ADDENDUM NO. 2

JUNE 8, 2017

**Tucson Airport Authority
Tucson International Airport
10112-254 Rehabilitate Runway 11L-29R and Connector Taxiways**

QUESTIONS/CLARIFICATIONS RECEIVED FOR PROSPECTIVE BIDDERS:

SHEET OVERVIEW TITLE	TYPICAL SECTIONS - RWY 11L-29R
SHEET REFERENCE NUMBER:	C451
SHEET	270 OF 410

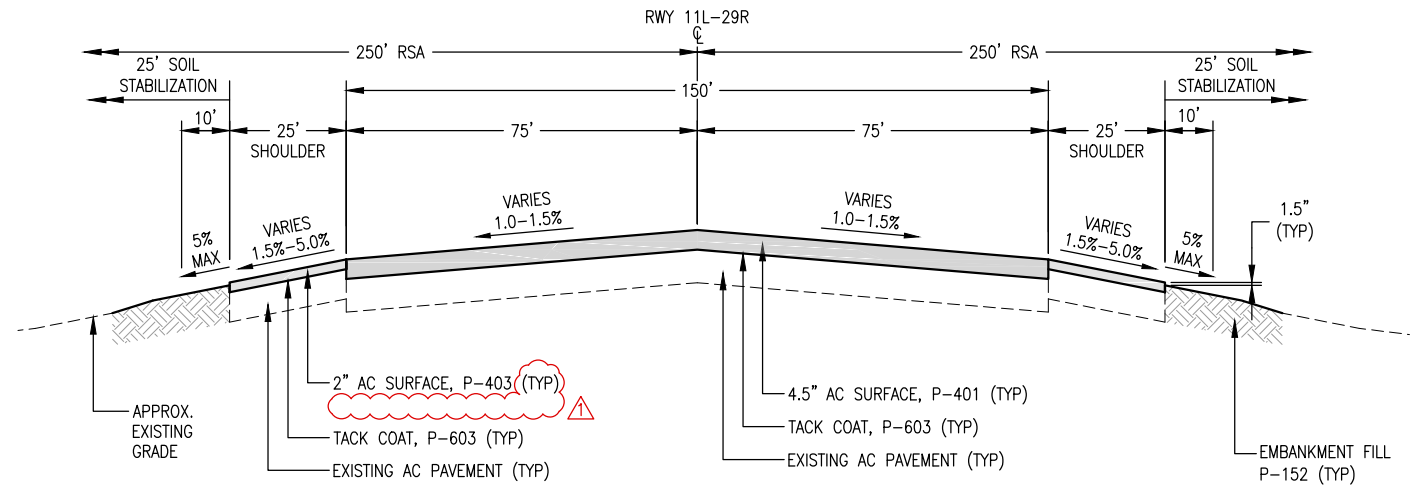
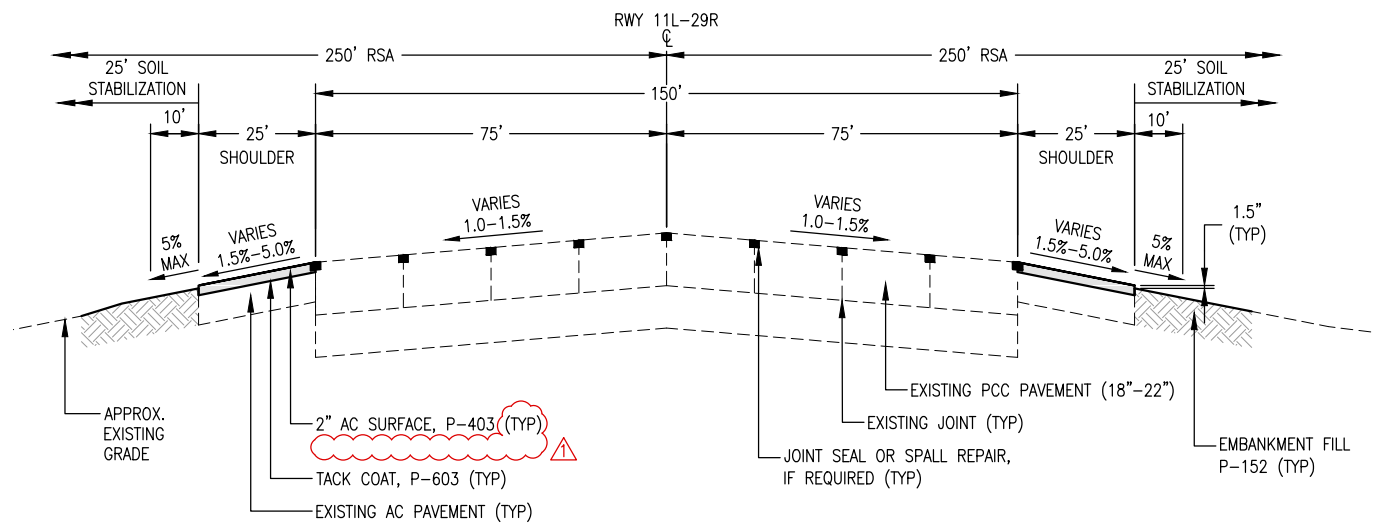
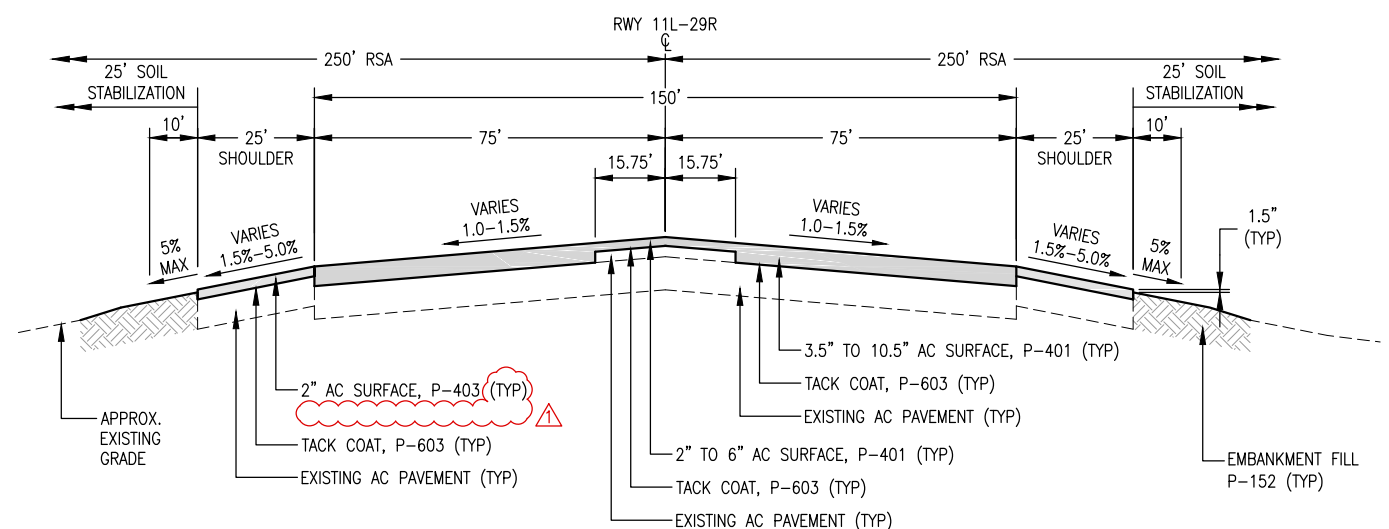
Sheet C451, TYPICAL SECTIONS - RWY 11L-29R

ANSWER- There was a typo in the bid documents for the reference. However, the use of ADOT asphalt has been deleted from project. The typical section drawings have been revised and are issued in Addendum 2.

SHEET REFERENCE NUMBER:
C452
 SHEET 271 OF 410

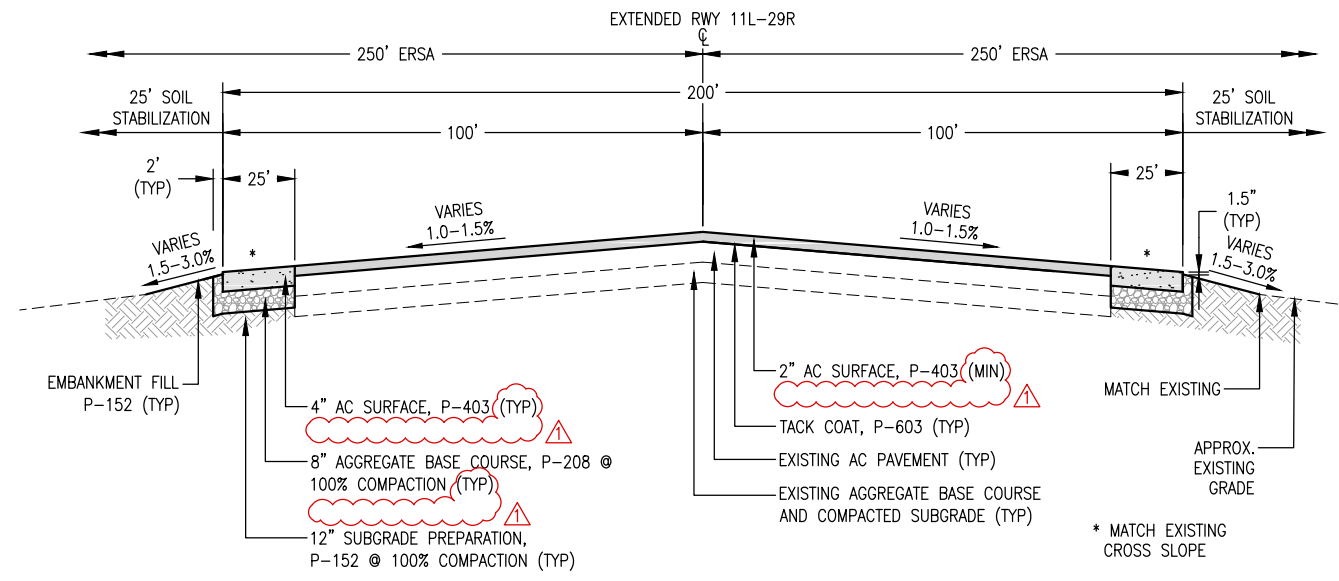
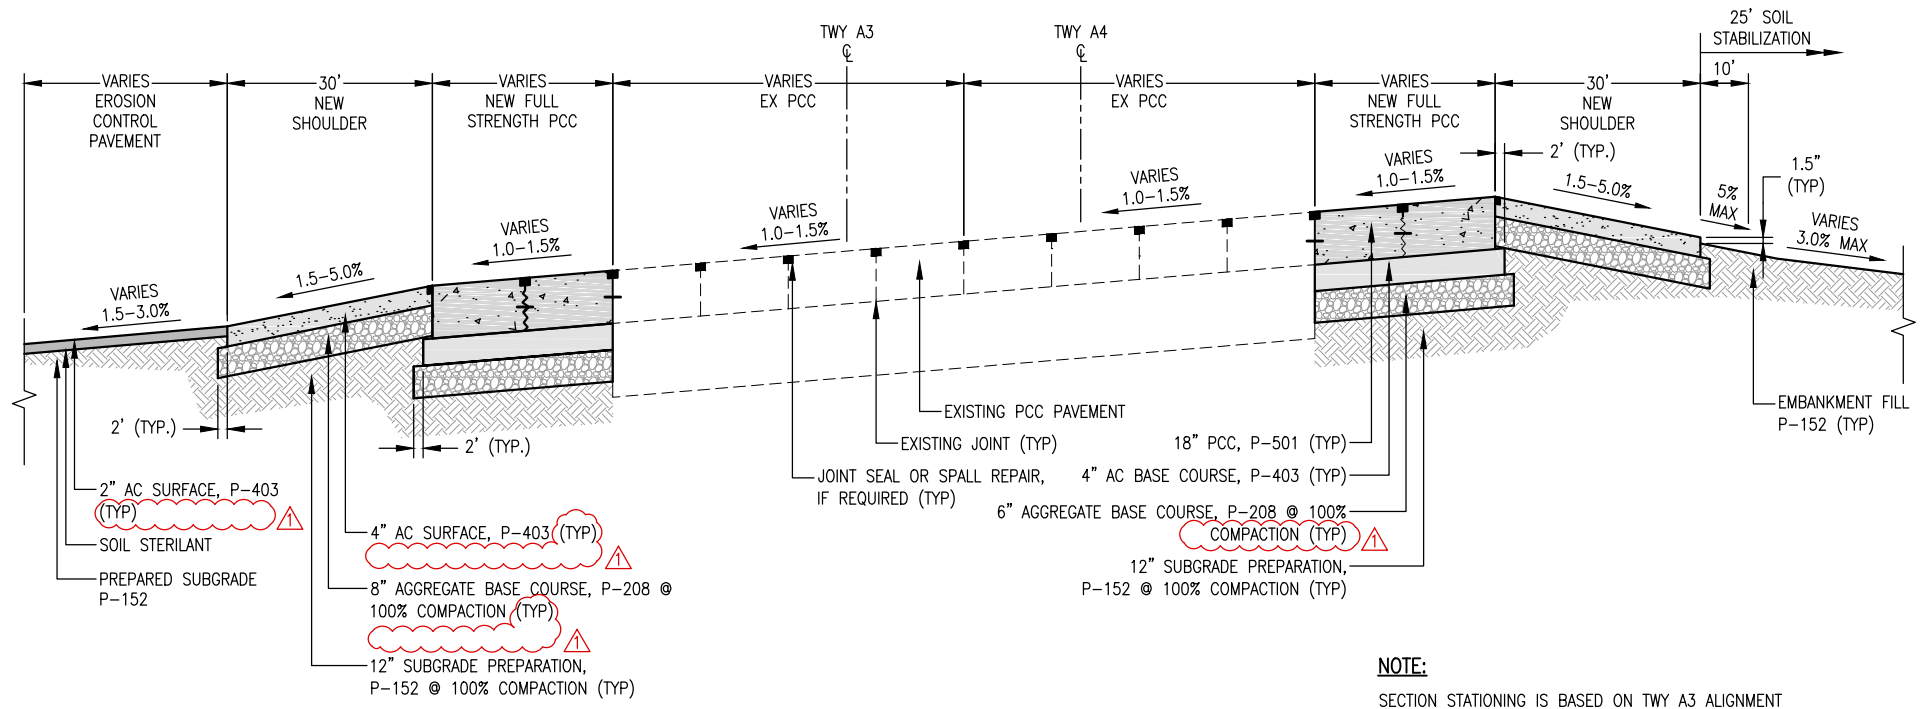
Sheet C452, TYPICAL SECTIONS – Blast Pad & TWY’s

SHEET REFERENCE NUMBER:
E107
 SHEET 371 OF 410

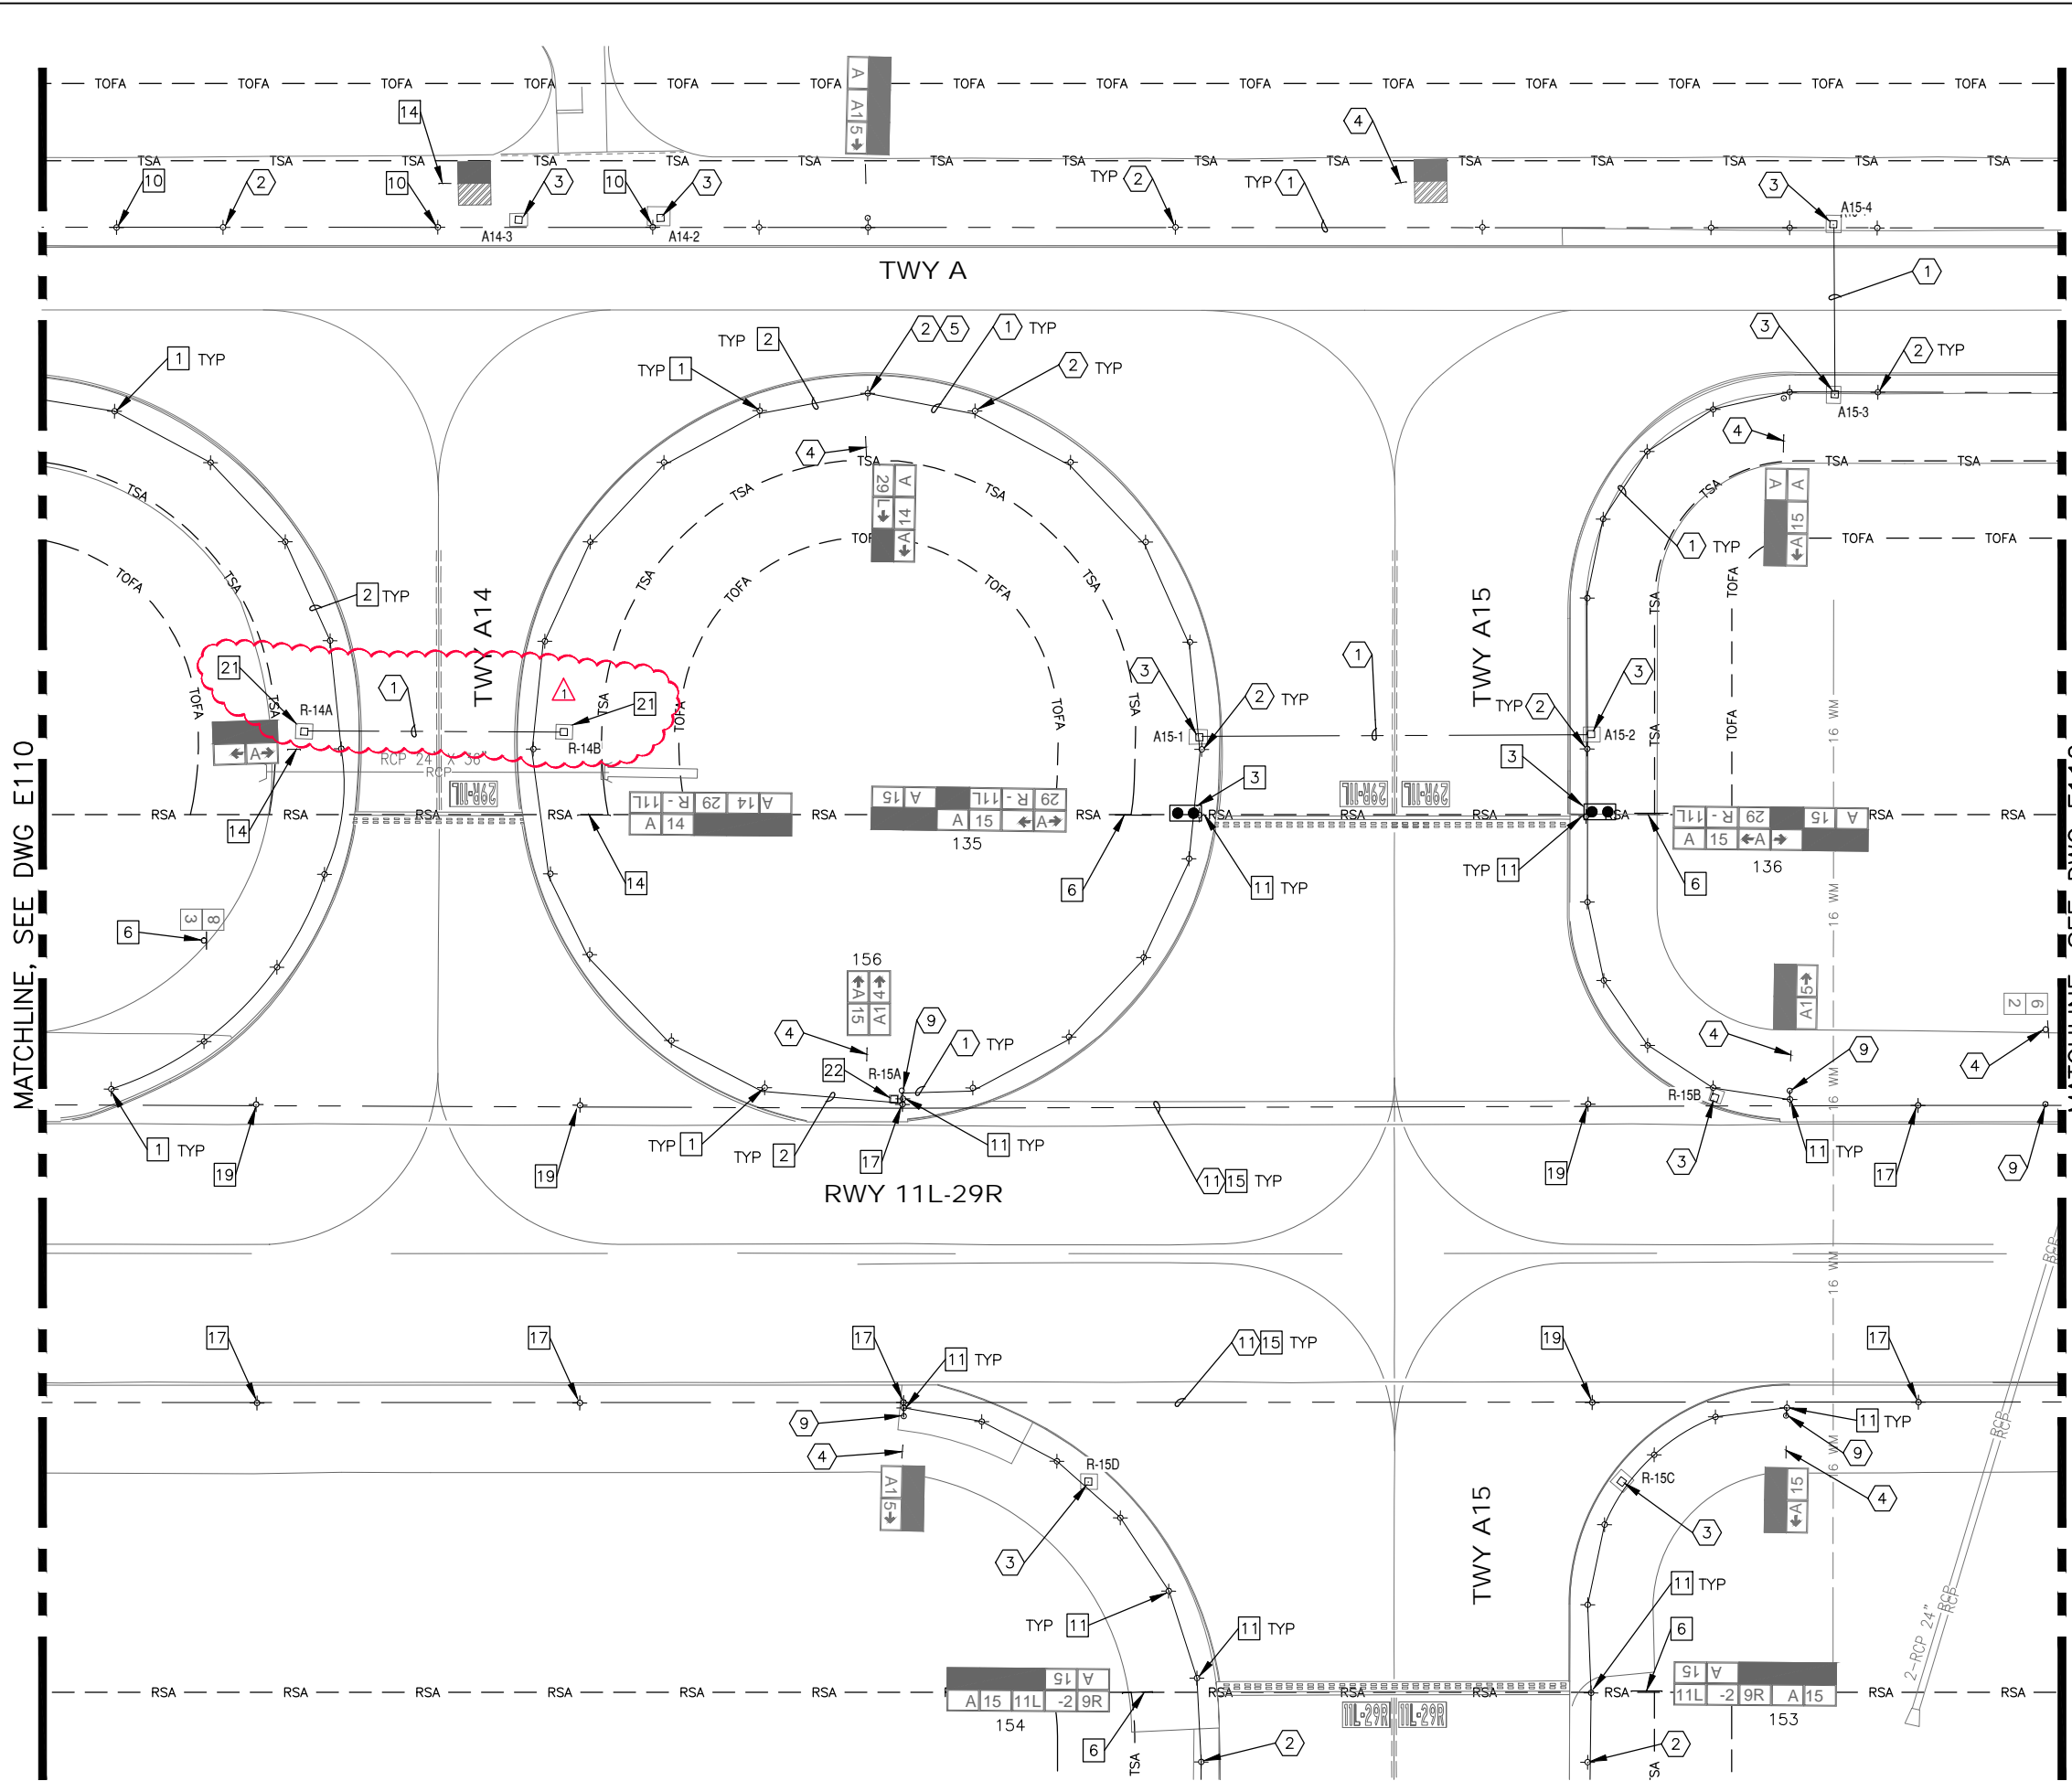
Sheet E107, AIRFIELD ELECTRICAL REMOVAL PLAN 07

ANSWER - Refer to sheet E107.
